## 8730 GREENWOOD AVE N.

RECOMMENDATION  
#3036533-LU 04/19/2021

EARLY DESIGN GUIDANCE RESPONSES | MASSING OPTIONS & RESPONSE TO ADJACENCIES

PREFERRED MASSING

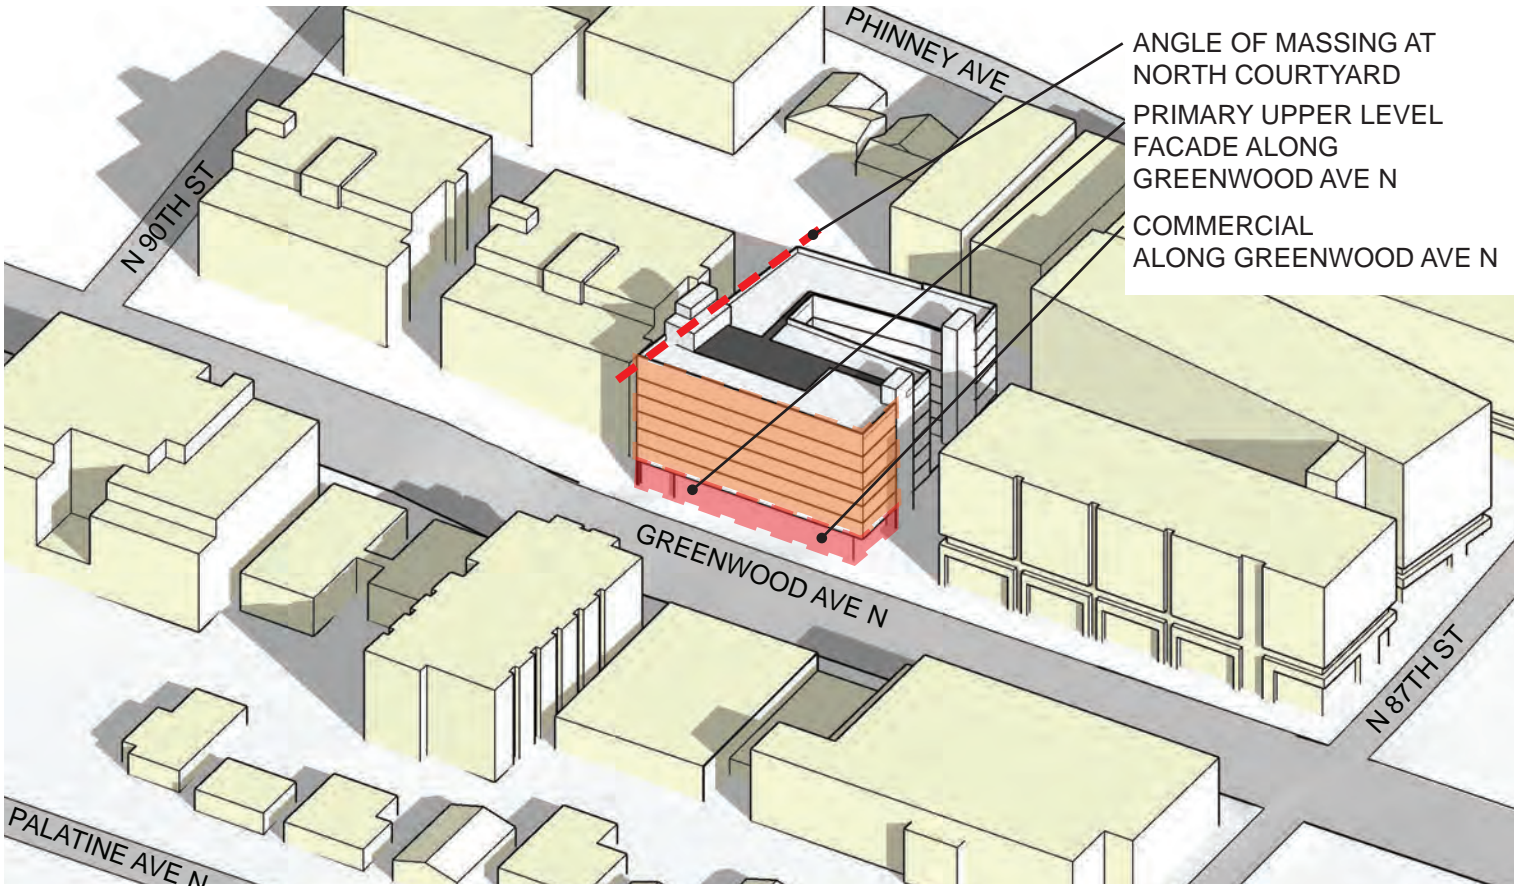
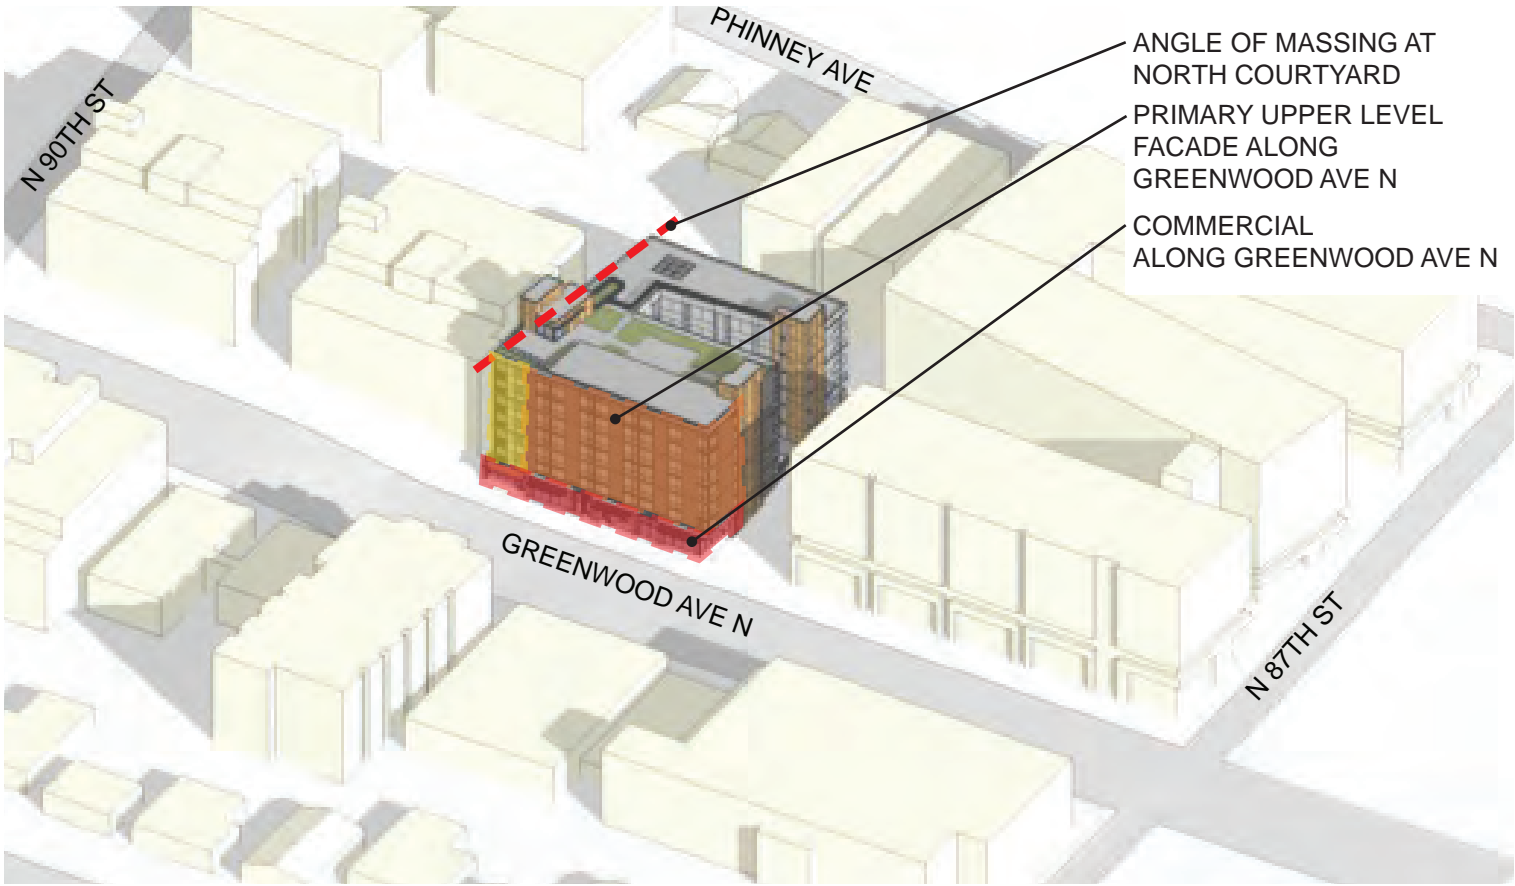
Board Guidance:

The Board supported the applicant’s preferred massing option A as the basis for further development for the following reasons:

- The canting of the massing along the north façade which provides a sensitive response to the neighboring buildings as well as retention of the line of trees along the north property line.
- The southern orientation of the courtyard and alignment with the courtyard of phase I to the south
- The strong massing response to the Greenwood Frontage
- The arrangement of ground floor uses including the residential lobby to the north and grouping of the commercial space.

Applicant Response:

The proposed design represents an evolution of Option A presented at the Early Design Guidance meeting, retaining the “canted” facades to the north and east, in response to the existing retaining wall, as well as the south facing courtyard that aligns with the open space on the phase 1 “Hemlock” project. The massing along Greenwood has maintained the strong street-level presence and simple upper story façade expression presented at the meeting, with changes to the northwest corner and building entry in response to the board’s guidance. The arrangement of uses on the ground floor is also as presented at the meeting, with a lobby on the north end and commercial spaces at the remainder of the street-level frontage.

NORTHWEST CORNER | ALTERNATE

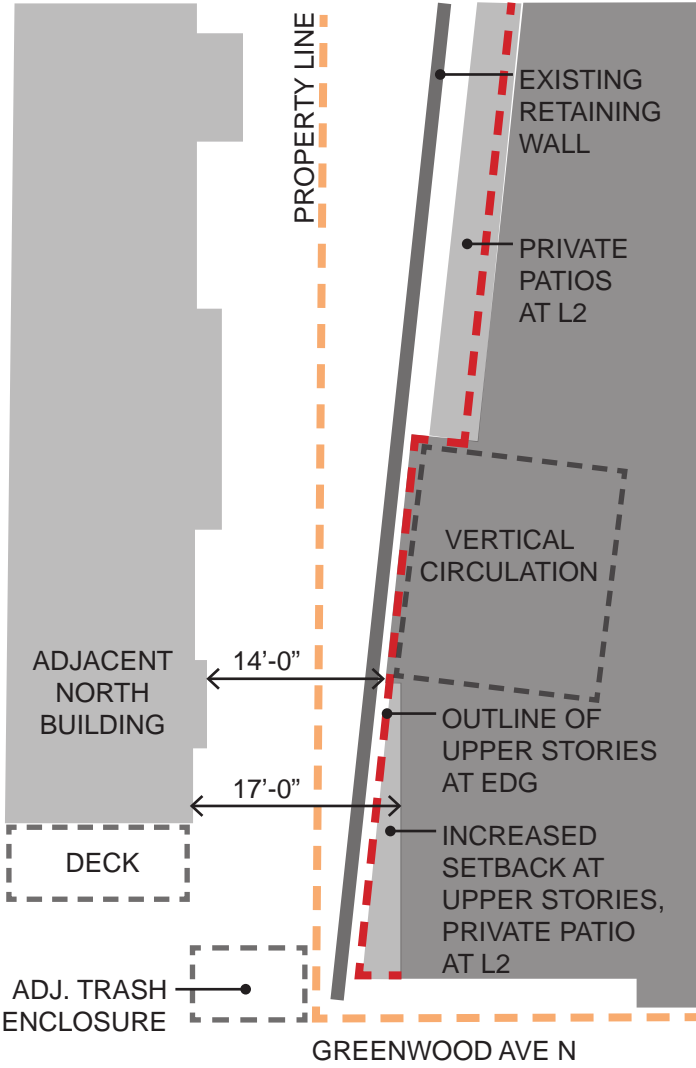
**Board Guidance:**  
The board discussed the northwest corner of the massing including the placement of the penthouse tower and the relationship with the neighboring residential building. The board was concerned about the potential impacts to the adjacent building including privacy and access to light and air. The board provided guidance to design the proposal to resolve these concerns, while also ensuring the corner is responsive to the overall neighborhood pattern of development and maintains a strong massing presence along Greenwood.

The board appreciated the angled facade following the existing retaining wall geometry, and the open space created, but expressed concern about the impact of the massing on the adjacent property at the northwest corner.

**Applicant Response:**  
*The northwest corner of the building has been pulled away from the north property line at the upper stories, increasing the access to light and air for the neighboring structure to the north. Additionally, the window arrangement, sizes, and location of the northwest unit has taken into account the neighboring fenestration patterns and uses. The penthouse volume has been retained in its location on the north edge of the structure. While the applicant understands the board’s concerns, the circulation tower is an appropriate adjacency as it a) maintains privacy for the neighboring residents, as there are less units facing their south facing windows, b) the penthouse provides a sound and visual buffer from the roof deck to the neighboring structure, and c) while the tower does cast a shadow due to its height, the additional impact is limited to the unoccupied roof and does not adversely impact the units more than any other part of the structure would in that location.*

The massing was pulled back at the northwest corner, creating more shared light and air for the units. The corner unit primarily faces west with only secondary high-sill windows on the north side to reduce visual reciprocity. The vertical circulation, while having extra height, are a program that doesn’t require additional windows, preserving privacy for the neighboring units. At the roof, the penthouse provides a visual and noise buffer between the occupied roof deck and the adjacent property.

Though code, privacy, and ground level program considerations support the proposed location of the circulation towers, this alternate study shifts the towers as far south as possible, given the tight site restraints for parking and commercial depth. This impacts the usable space and flow of the lobby at the ground floor, as well as encouraging additional windows to be located on the north facade, reducing privacy for the neighboring units. Furthermore, the proposed configuration shifts more rooftop activity to the north edge increasing potential noise impacts to the adjacent property. The modest reduction in height at the north facade from the proposed does not justify the other potential impacts to the adjacent property.

WEST FACADE

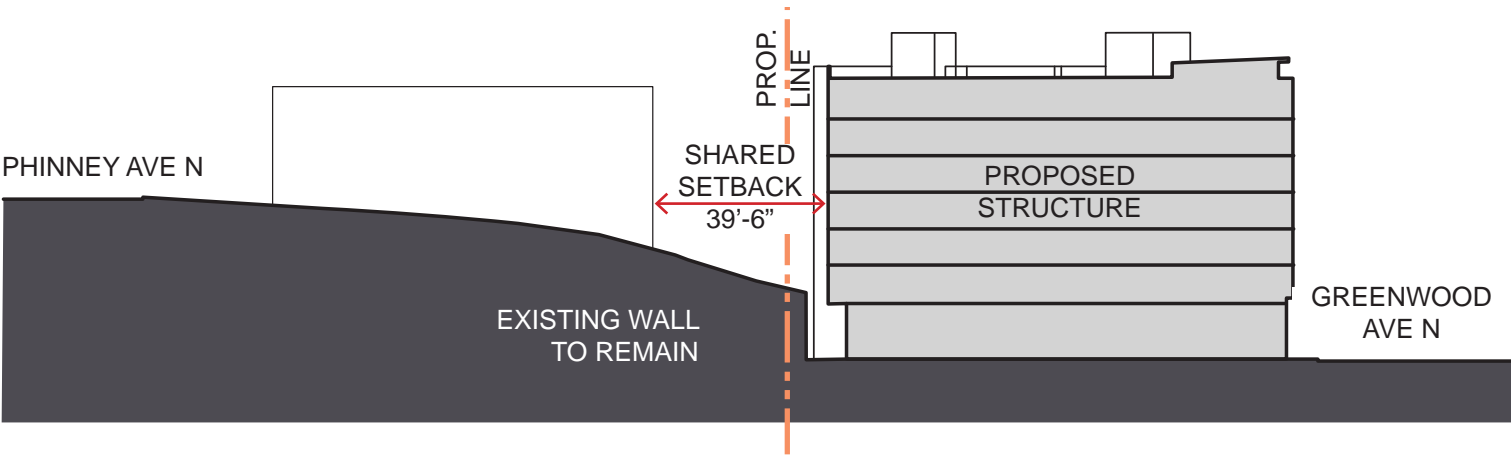
Board Guidance:

The board provided guidance to explore differentiation between the base and the upper levels, which could be key to resolving guidance regarding the northwest corner.

Applicant Response:

The street-level expression has remained separate and distinct from the upper story massing. The street-level carries the retail bay expression integral to the Greenwood Ave corridor north, extending the pedestrian-focused streetscape from the south. The upper stories rise above the masonry frames of the retail bays, with evenly spaced, organized fenestration and clean material detailing, providing a complementary contrast with the street-level. This contrast also allows for the northwest corner to be pulled away from the south property line while still maintaining a strong street-edge at the pedestrian realm.

STREET LEVEL LANDSCAPE PLAN

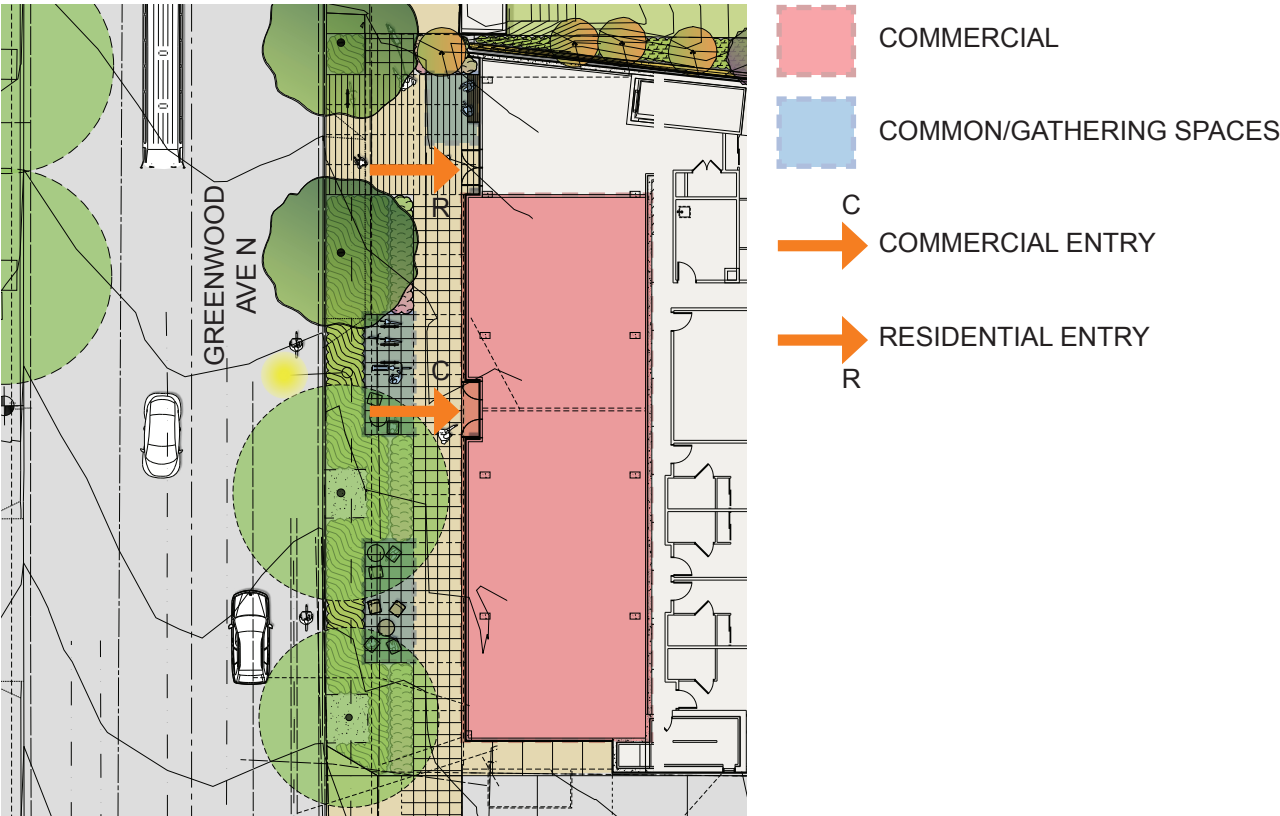
Board Guidance:

The Board supported the consolidation of the commercial spaces option and the continuity of the commercial expression along Greenwood Ave from Phase 1. The board provided guidance to study how space can be allocated in the right-of-way landscape strip as “pocket amenity areas” and how the placement relates to the rhythm of commercial spaces and residential lobby.

Board Guidance:

The board provided guidance to further differentiate the residential entry from the commercial frontage. The board requested pedestrian level perspectives and detailed street-level drawings be provided the Recommendation packet illustrating the pedestrian experience and street level detailing.

Applicant Response:

The commercial space(s) still occupy the majority of the street frontage, set within masonry bays that reflect the existing patterns, rhythms, and felling of the Greenwood Ave commercial corridor. The residential lobby is pushed to the north end of the site which both relates to the existing context and patterns of the neighborhood, but also allows the commercial space to be continuous with the retail space at L1. Additionally, by establishing a single, continuous commercial space, there is flexibility to subdivide the space or maintain a single large space as the neighborhood’s retail needs change over time.

The landscape concept provided at the EDG meeting has been further developed, but maintains the small “eddies” of gathering space between the street and sidewalk within the planting strip. The location of these spaces wrap around the existing street trees to remain, and are programmed to match the needs of the adjacent uses, such as seating and short-term bike parking for the commercial spaces, and a more open “plaza” expression that connects the street to the residential entry with distinctive pavement patterning and open sight lines.

Applicant Response:

Careful design cues help locate and differentiate the residential entry from the rest of the structure, both at the street level and within the context of the architectural design of the building overall. At the street level, fractured brick bays frame the commercial frontage, before a modest setback, unique pattern of the pavement, and a change in the façade establish a new language for the residential lobby frontage. The materiality change and slight setback carry up the building façade, creating a larger gesture that announces the residential entry, while maintaining the strong, simple massing expression along the rest of the street-facing façade.
